VALIDATION OPINION

On a Revision in Monitoring Plan (Rev. 2)

**"Korea East-West Power Dangjin Small
Hydro Power Plant Project (5MW)" in Korea
(UNFCCC Registration No. : 2366)**

Report No. CDM-11-007A

Figure 1 Measuring System Diagram

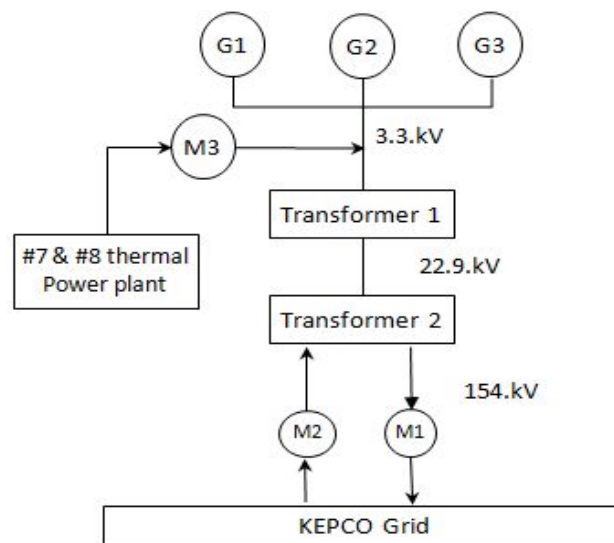
The revision of monitoring plan is carried out to enhance the level of accuracy and completeness in the monitoring and verification process as per paragraph 202 of the VVM (version 1.2). According to the monitoring plan in the registered PDD, data and parameters monitored (B.7.1) is described only EGy - 'net electricity supplied to the grid by the project activity in year y. During the initial and 1st verification period (01/01/2010 to 31/03/2011), it was noticed that there are 3 watt-hour meters involved in the monitoring system of the project activity as see "Figure 1 Measuring system diagram", namely one for the export electricity and two for the import electricity as follows;

- Transmission electricity (EG_{out} , M1) is measured by the export watt-hour-meter which the accuracy of the equipment is 0.5S ($\pm 0.5\%$) under KPX (Korea Power exchange) control.
- One import electricity ($EG_{in,1}$, M2) is measured by the import watt-hour-meter which the accuracy of the equipment is 1.0S ($\pm 1.0\%$) under KEPCO (Korea Electric Power Corporation) control.
- The other import electricity ($EG_{in,2}$, M3) is measured by the import watt-hour-meter which the

accuracy of the equipment is 1.0S ($\pm 1.0\%$) under the project participant's (Korea East-West Electric Power Corporation) control. This import electricity ($EG_{in,2}$) will not be supplied into the project activity from #7 and #8 thermal power plants in the ordinary situation and will be used only emergency situation when KEPCO could not supplied to the project activity due to unpredictable situation. But this monitoring point (M3) was not stated in monitoring plan of the registered PDD.

And also monitoring plan including metering system as well as the quality of monitoring equipment (eg. accuracy, calibration requirements) are not concretely described in the monitoring plan of the registered PDD.

Thus KSA has concluded that the project activity is required to revise the monitoring plan to enhance the accuracy and completeness in the monitoring and verification process.
